**EVALUATION OF HALTON REGION
LANDFILL TECHNICAL STUDIES
Site D - Milton**

HYDROGEOLOGIC REPORT

- **Part A - Definition of Hydrogeologic Suitability
for Landfilling**
- **Part B - Critique of Trow Technical Studies**
- **Part C - Interpretation of Site D Hydrogeology and
Suitability for Landfilling**

February 8, 1988

figure B2.1

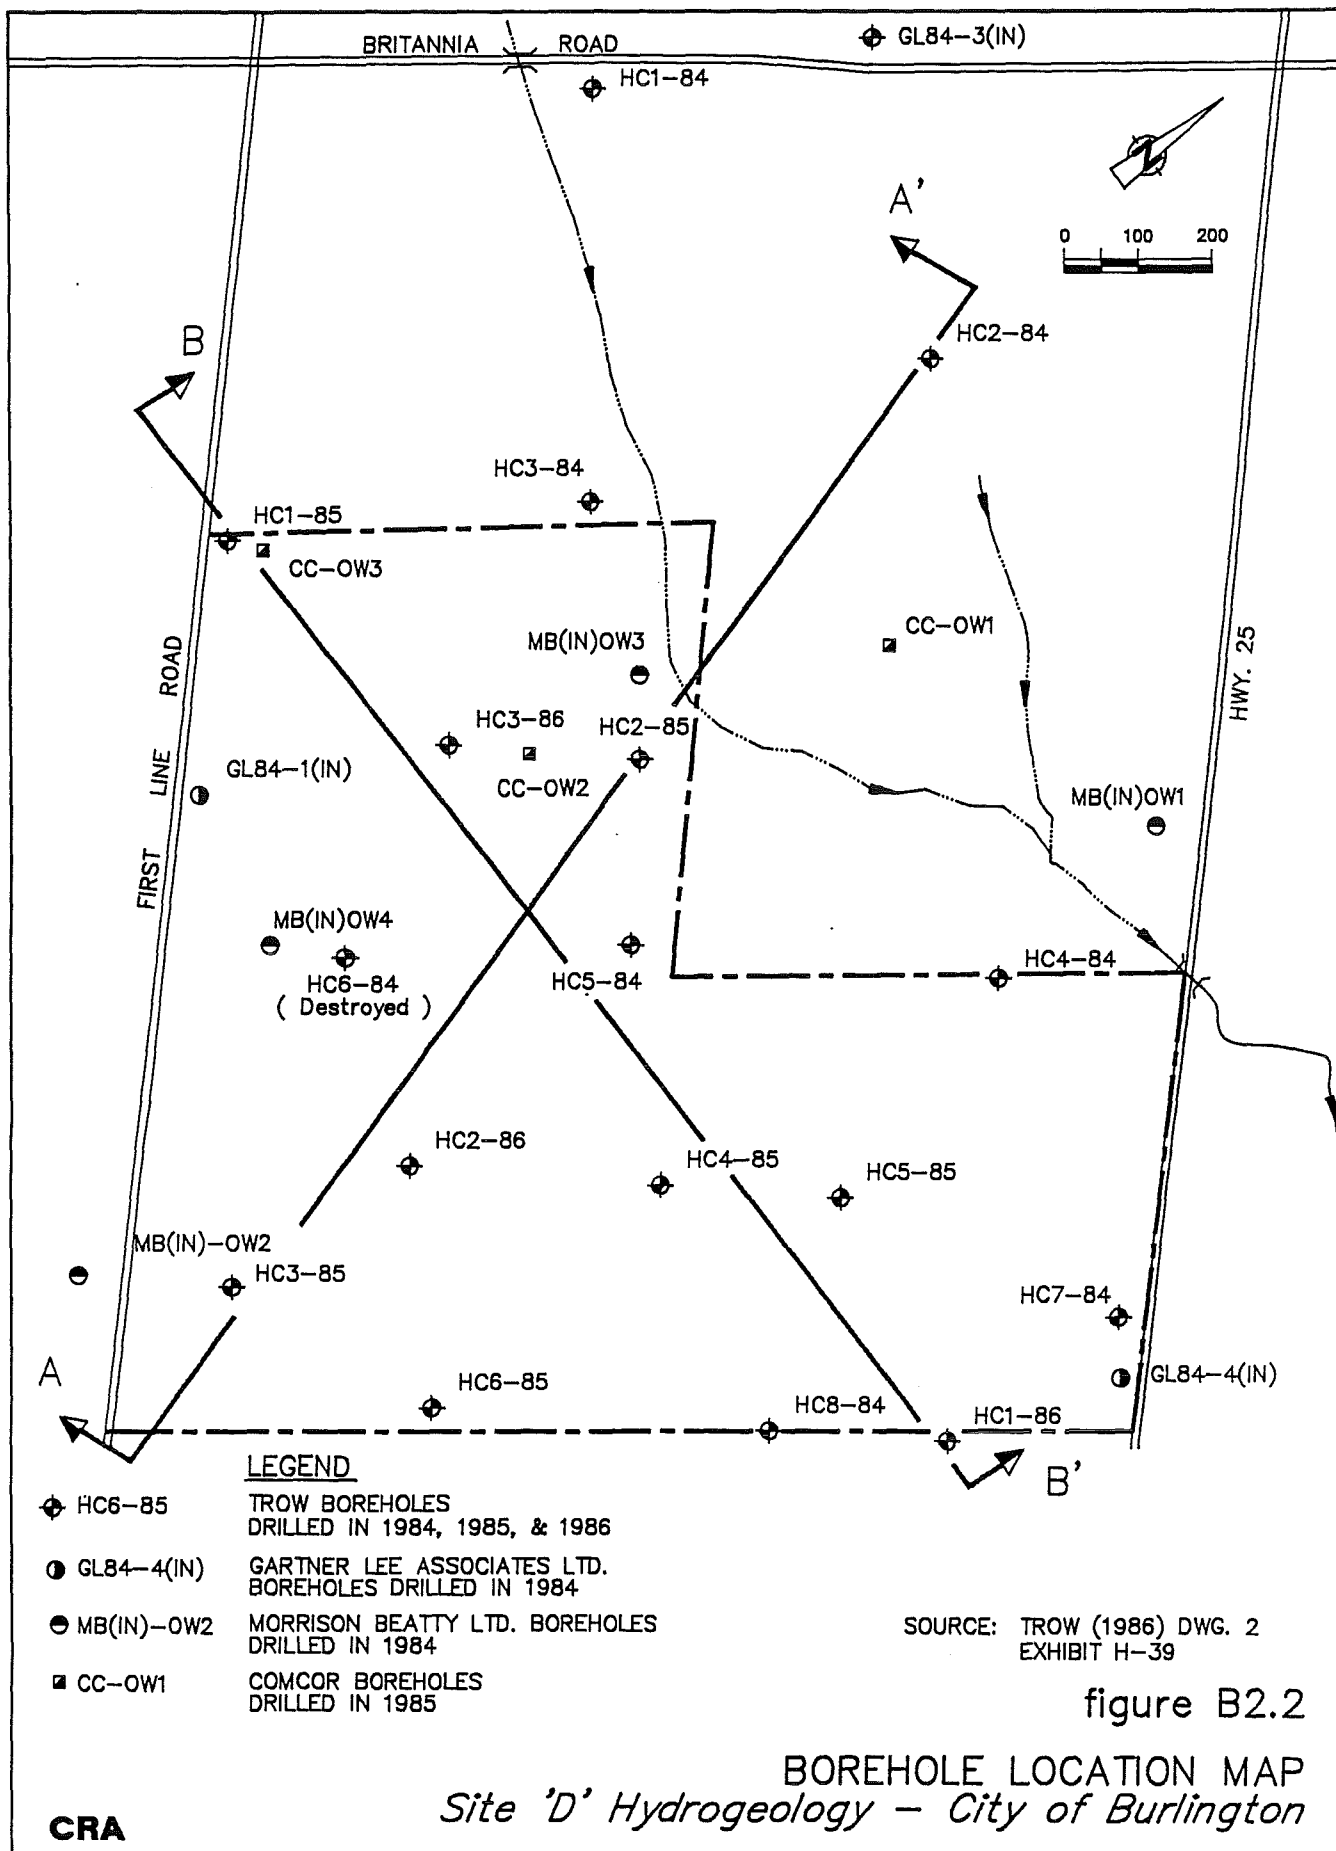
The Upper Till Unit was encountered near surface in each of the 29 boreholes drilled in the vicinity of Site D. It should be noted that only 27 boreholes are identified on Figure B.2.2 (p. 19). The remaining two boreholes, GL84-5(IN) and GL84-2(IN) are located west and southwest of the site respectively as shown on Plan 1 (backpocket). The thickness of the Upper Till Unit as interpreted by CRA from the borehole logs (Trow, Appendix 2, Exhibit H-39A), was observed to vary between 4.45 m (CC-OW1) located north of the site and 12.2 m (HCl-86). The average thickness using information from all boreholes is 7.74 m. If the 1984 series boreholes are not included due to the uncertainty in defining stratigraphic horizons, the average thickness is 8.1 m. This is consistent with the value of 8 m shown on Trow's schematic cross-section (Figure B.2.1, (p. 18)).

The uppermost portion of the Upper Till Unit is weathered and fractured. The depth of penetration of weathering and frequency of fracturing are not described in equal detail on all borehole logs. The depth of weathering is not shown by Trow for each borehole on the cross-sections, but is shown on the schematic cross-section (Figure B.2.1, p. 18) as being 4 m in depth.

Exhibit H-39A). The thickness of the described weathered zone varies between [1.5 m (OW3-86) and 9.5 m] (CC-OW3). The average thickness of the weathered and fractured zone is 4.02 m which is consistent with the value of 4 m used by Trow (Figure B.2.1 (p. 17)).

The Lower Granular Unit is interpreted by Trow as a relatively a laterally extensive layer of silt and fine sand which occurs at and below an approximate elevation of 170 m. As determined from the available borehole logs, CRA has identified this unit in 14 boreholes with thickness that varied from 0.25 m (CC-OW2) to 4.9 m (HC4-85). The average thickness of the Lower Granular Unit is approximately 1.68 m. Trow reports an average thickness of 2 m for this unit (Figure B.2.1, p. 18).

figure B4.1

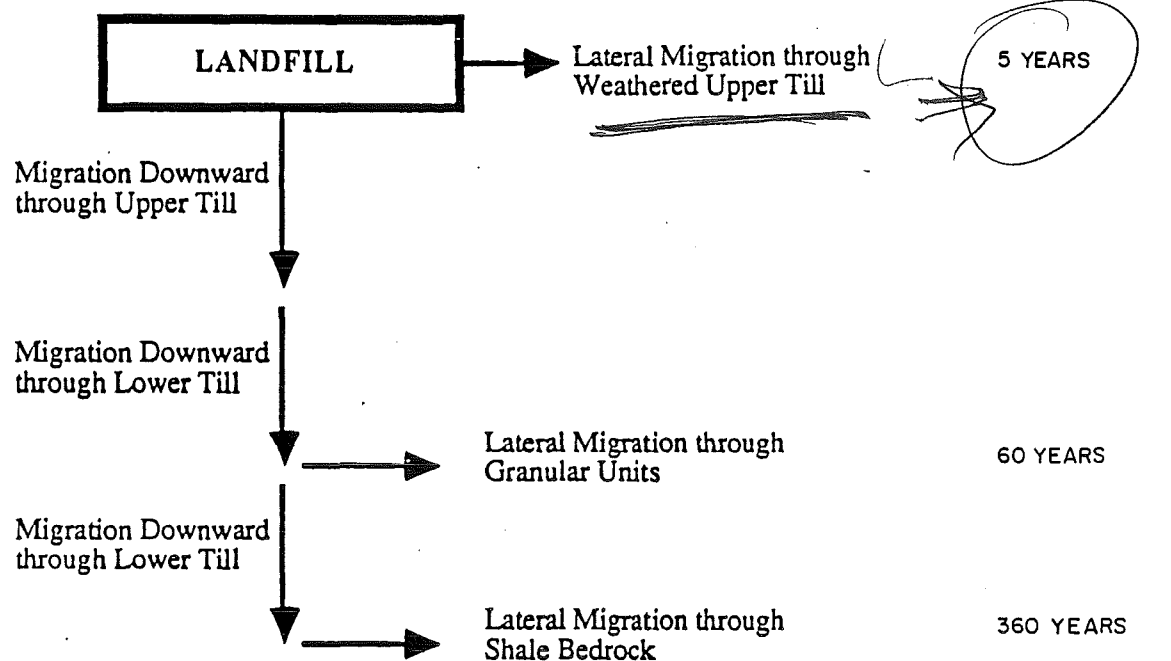
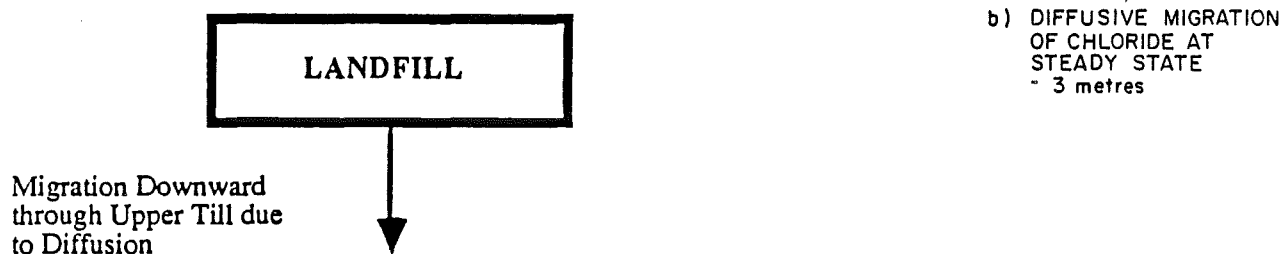
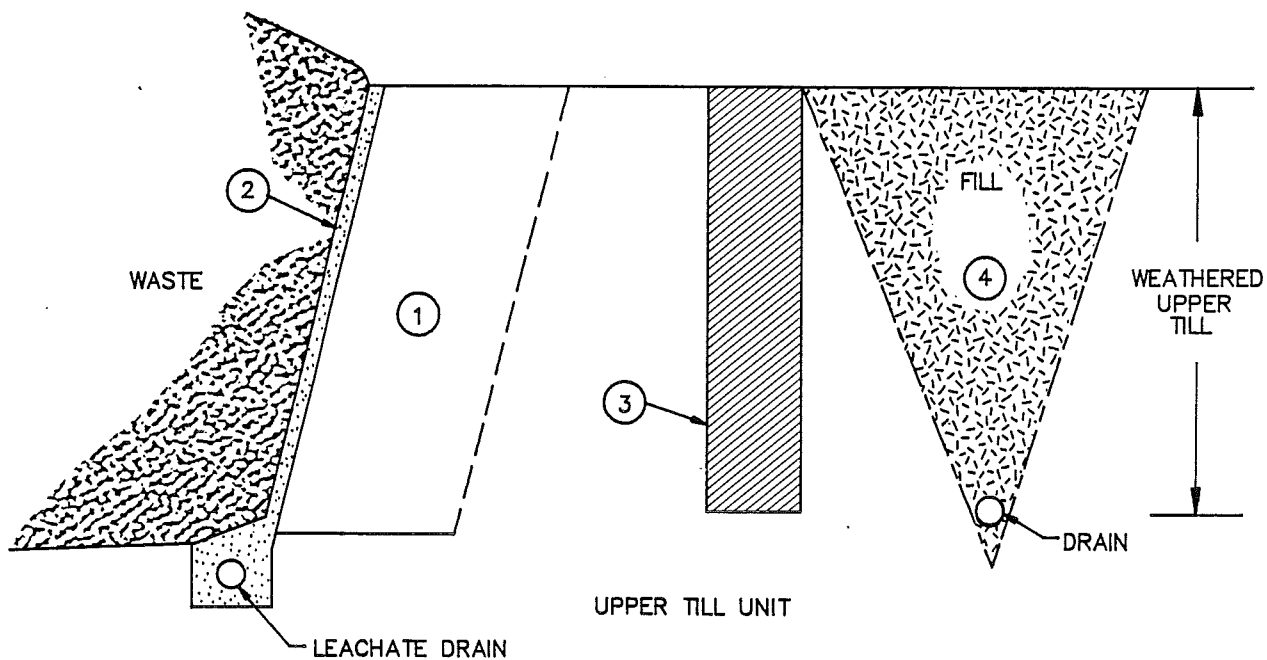
As shown on Figure B.4.1 (p. 53) Trow concludes that contaminants can migrate to the site boundary in five years. An arrival time of five years is considered by CRA as unreasonable.

Trow indicates (p. ix, Exhibit H-39) that experience gained at other similarly sited landfills in Ontario shows that rapid migration through the weathered zone has not been detected. However, it is recognized that the hydrogeologic conditions governing flow in such zones are not fully understood.

With respect to landfilling in fractured clays, the uncertainty regarding the hydraulics of these materials can be addressed by:

- 
- 1) Recompacting the sidewalls of the excavation to provide a low permeable barrier.
 - 2) Providing a permeable drainage layer with connection to the leachate collection system.
 - 3) Installing a cut-off wall around the outside of a completed excavation.
 - 4) Installing a perimeter drain around the outside of a completed excavation.

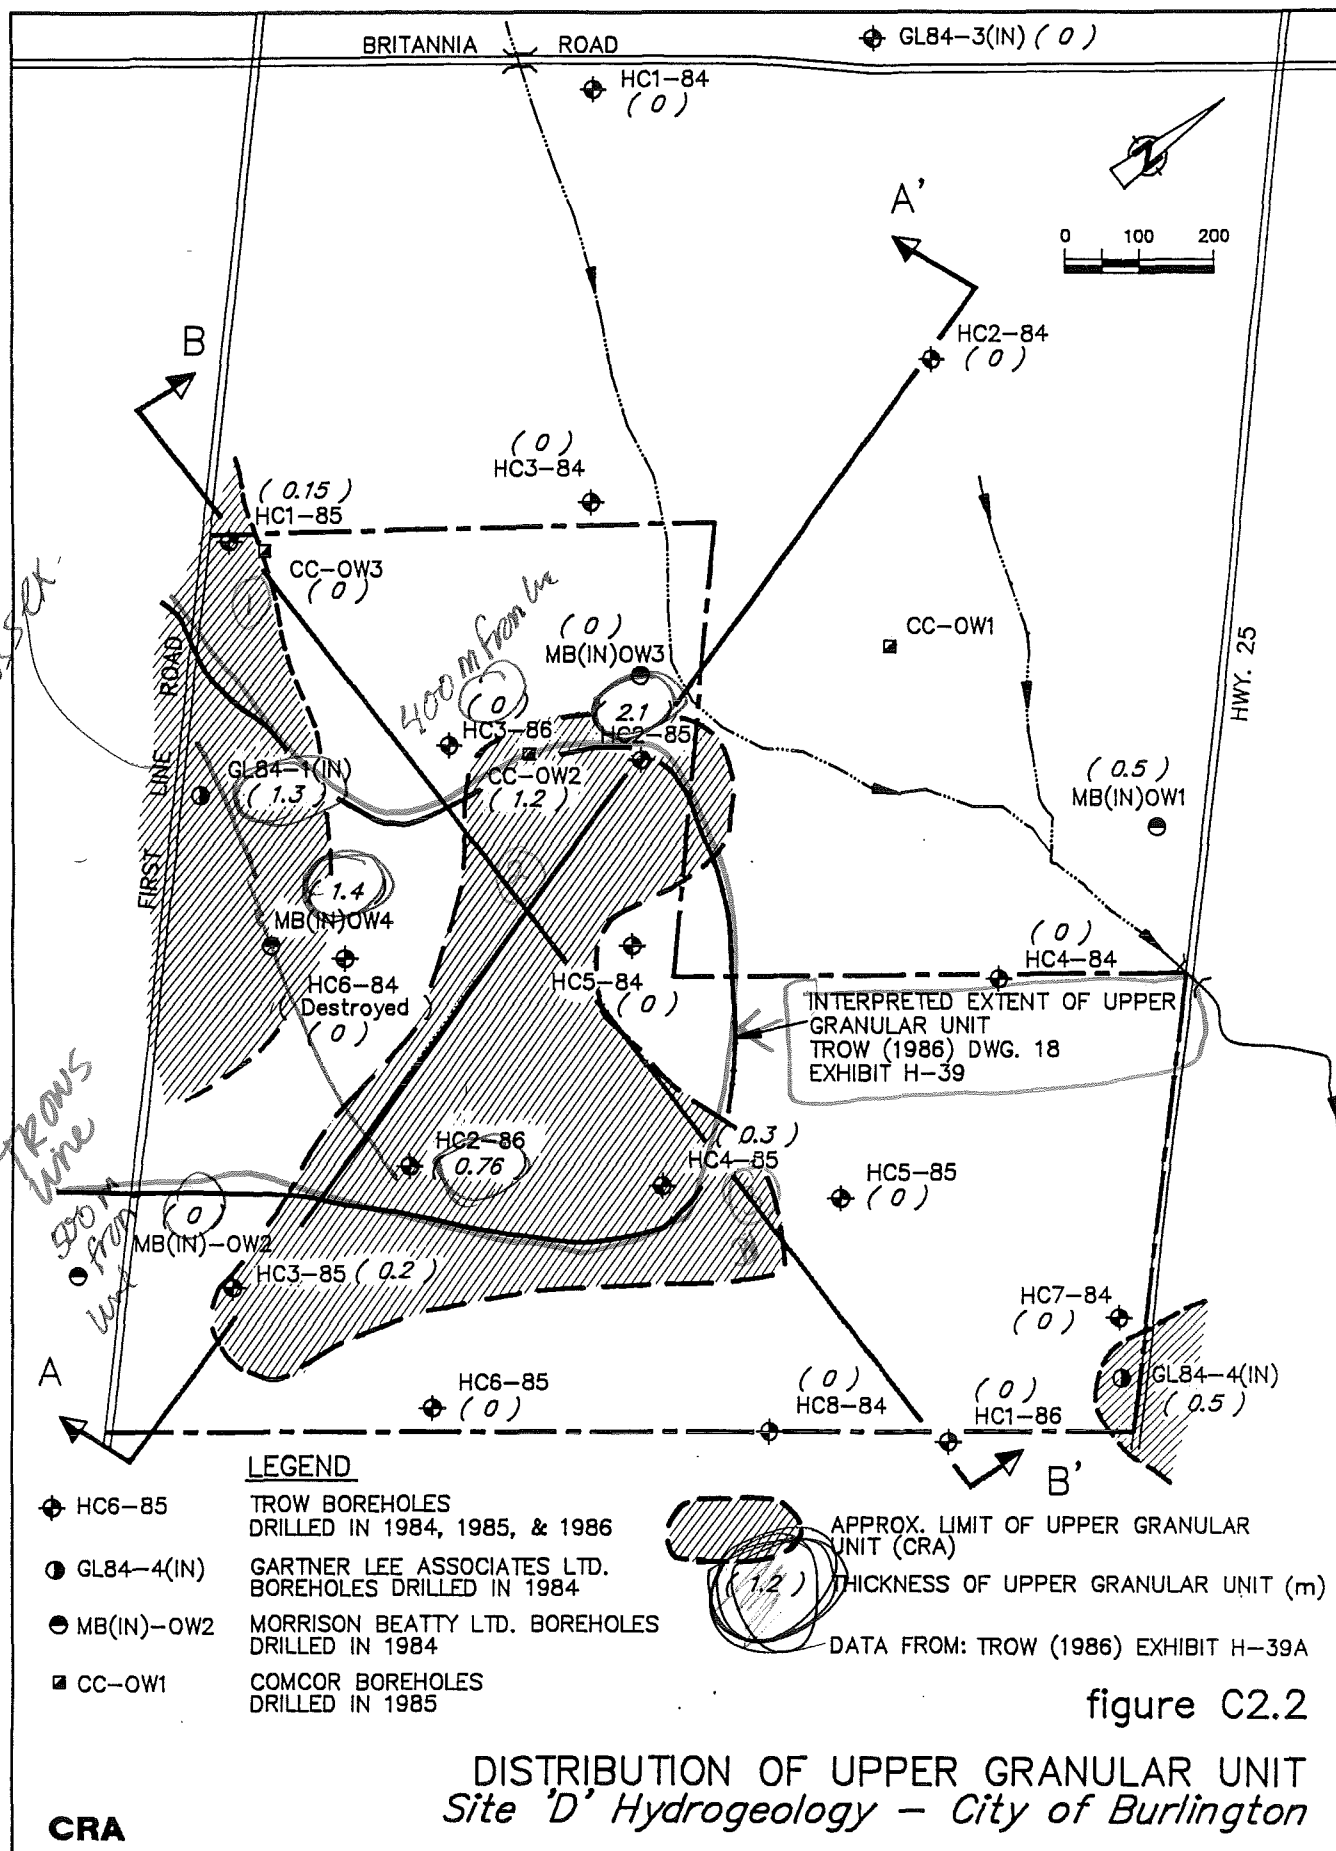
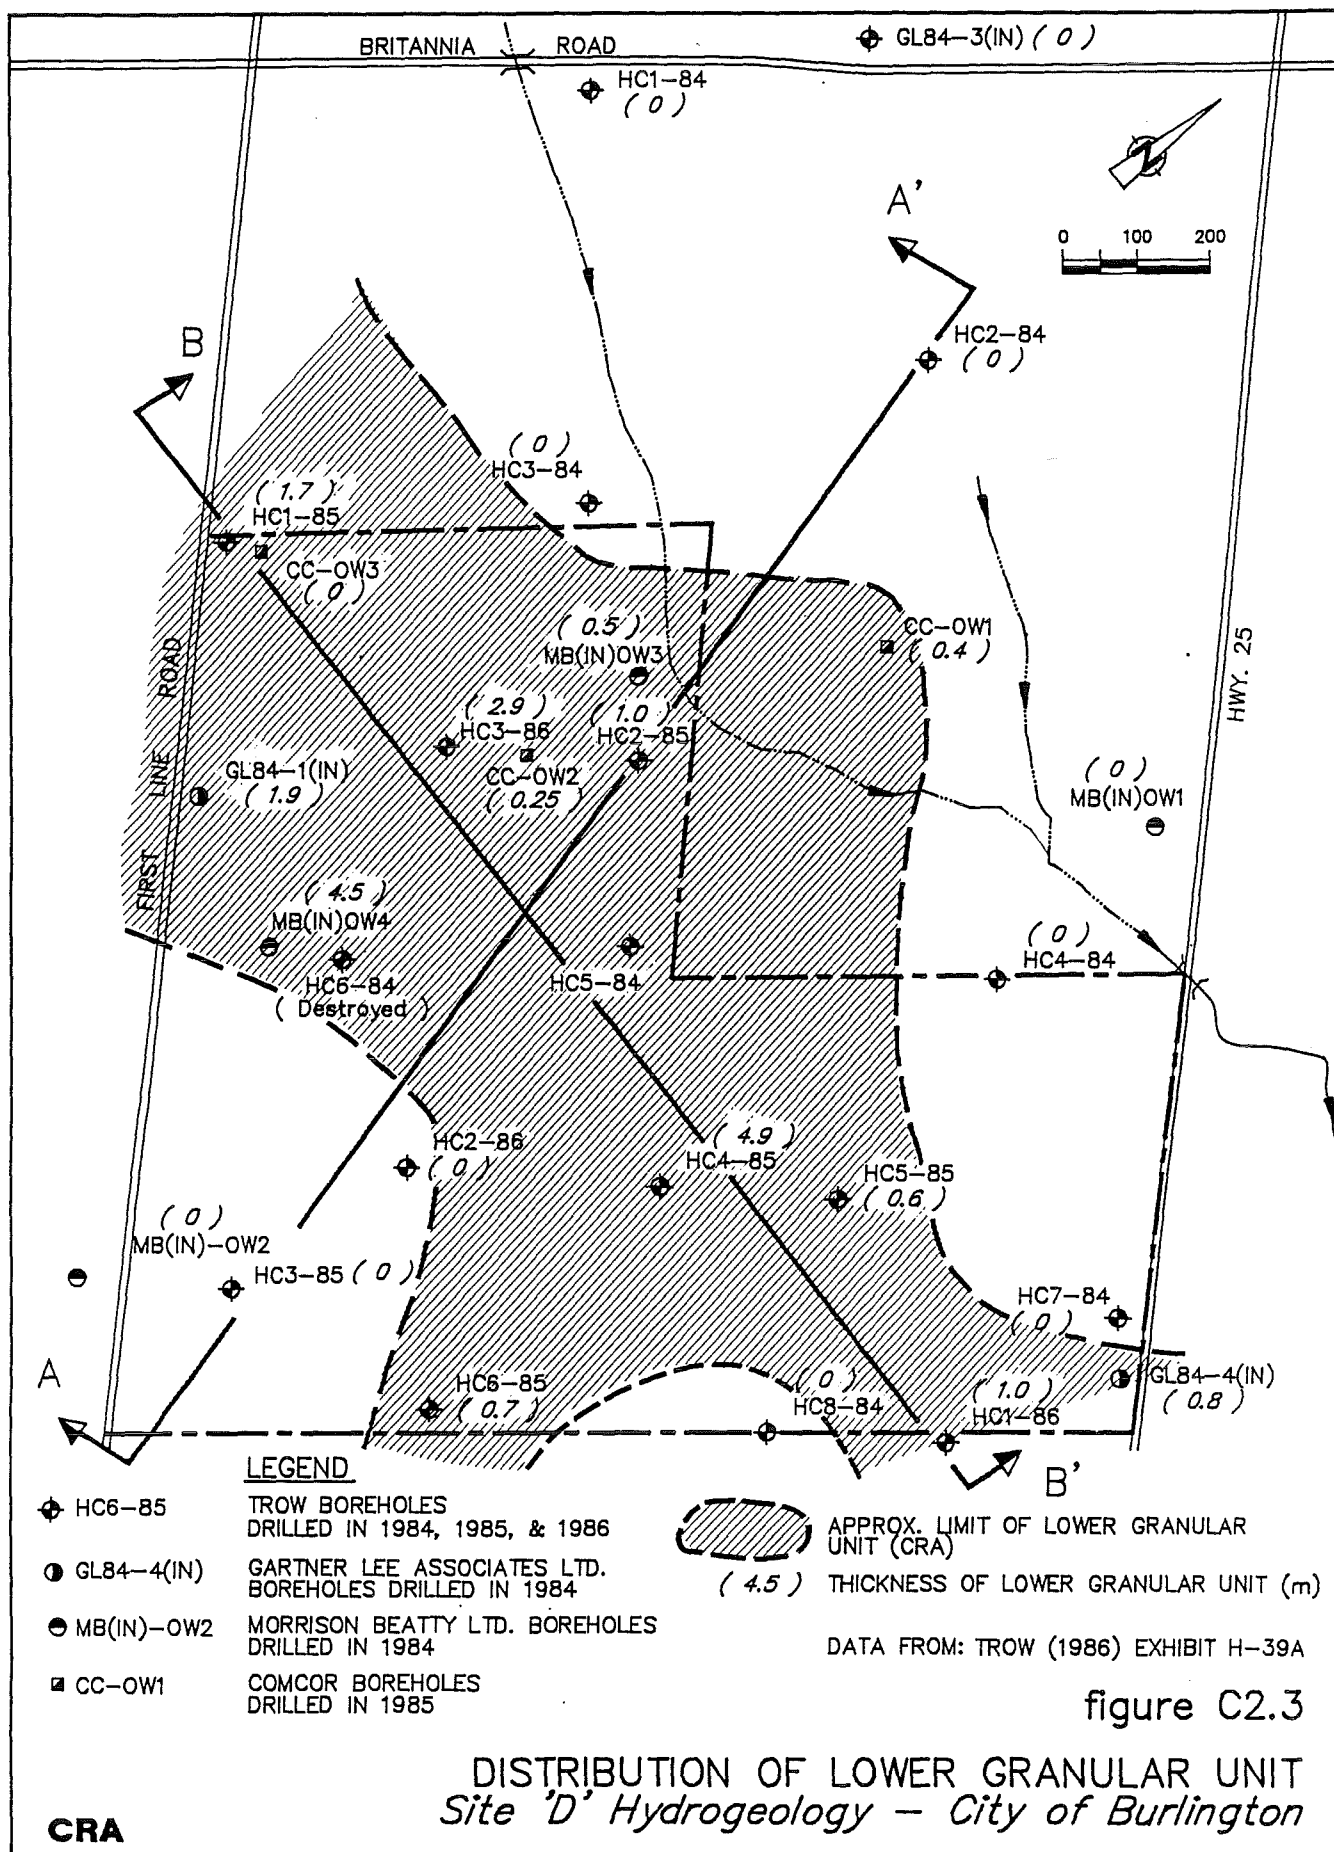
The distribution of the ^GUGU is shown on plan view as Figure C2.2 (p. 81). In addition the distribution shown by Trow (Drawing 18 Exhibit H-39) is also shown.

As shown on Figure C.2.2 (p. 81), CRA interprets that this unit is laterally discontinuous beneath the site and consists of two lenticular shaped bodies, the western one of which is interpreted to extend off site to the west. This interpretation is confirmed by the results of the pumping tests as discussed in B.3.2.4 (p. 40) of this report.

CRA concludes that the UGU does not provide a continuous permeable horizon from beneath the site to the western property boundary. This unit has a more restricted distribution than that interpreted by Trow.
